## Rewiew Otto Kalliorinne

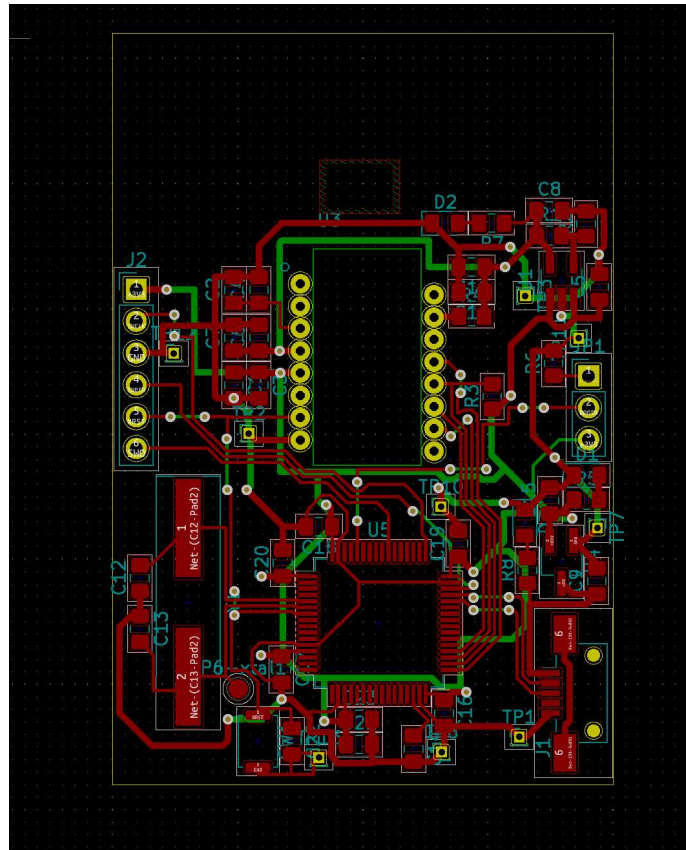
At first glance, the components are well positioned and the routing the traces are well made.

The only thing that could be said is that the cut-out for the PMW3389DM is on top of the component and should be inside.

On the other hand, you have not drawn a filled zone in the rectangle, associate it to the GND net nor for the black layer.
